Access Compliance Report

Public Rights-of-Way

(Curb Ramps)

Intersection ID: 10036601	Main Street: RUSHMORE_DR	Cross Street: N/A	Location: NE
ADA ID: DEF1F418F3B8	Ramp Type: PerpDiag	Initial Pass/Fail: Fail	Overall Compliance: No
Severity Score: 50			
Codes/Mitigation Info/Possible Solution		Field Measurements/Component Compliance

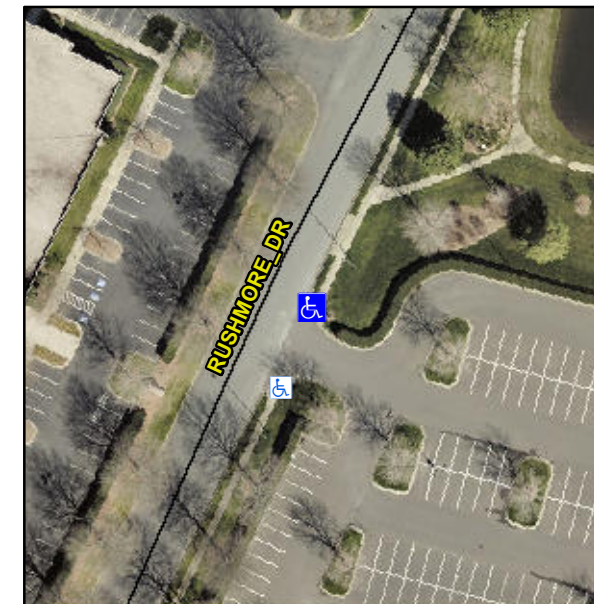
R304.2.2, R304.5.3

Compliance	Description	Data	Compliance	Description	Data
N/A	Ramp Length (in)	51.0	No	Ramp Slope (%)	14.9
Yes	Ramp Width (in)	63.0	No	Ramp XSlope (%)	7.3
N/A	Flare Type LT	N/A	N/A	Flare Type RT	N/A
N/A	Flare Slope LT (%)	N/A	N/A	Flare Slope RT (%)	N/A
N/A	Flare Traversable LT?	N/A	N/A	Flare Traversable RT?	N/A
N/A	Landing Length (in)	N/A	N/A	DWS Provided?	N/A
N/A	Landing Width (in)	N/A	N/A	DWS Contrast?	N/A
N/A	Landing Slope (%)	N/A	N/A	DWS Length (in)	N/A
N/A	Landing X Slope (%)	N/A	N/A	DWS Full Width?	N/A
N/A	Landing Curb? (Y/N)	N/A	N/A	DWS Offset (in)	N/A
N/A	Shared Landing?	N/A			
N/A	Gutter Ponding?	N/A	N/A	Gutter Slope (%)	N/A
N/A	Gutter Lip Ht (in)	N/A	N/A	Gutter X Slope (%)	N/A
N/A	Painted X Walk1?	No	N/A	Painted X Walk2?	No
	X Walk 1 Direction	To NW		X Walk 2 Direction	To SW
N/A	X Walk 1 Width (in)	N/A	N/A	X Walk 2 Width (in)	N/A
	X Walk 1 Slope (%)	0.0		X Walk 2 Slope (%)	0.2
	X Walk 1 X Slope (%)	0.5		X Walk 2 X Slope (%)	5.6

N/A	Ramp inside XWalk1?	N/A	N/A	Ramp inside XWalk2?	N/A
	Road Slope (%)	3.9	N/A	Clear Space?	N/A
	Road X Slope (%)	2.8	N/A	Clear Space to XWalk (in)	N/A
N/A	Any Obstructions?	N/A	N/A	Storm Grate/Utility Hazard?	N/A
	Obstruction Type			Storm Grate/Utility Type	
		N/A			N/A
		Yes		Surface Condition? (G/P)	Good

Remove & Replace Curb Ramp With Two New Directional Ramps or Equivalent.
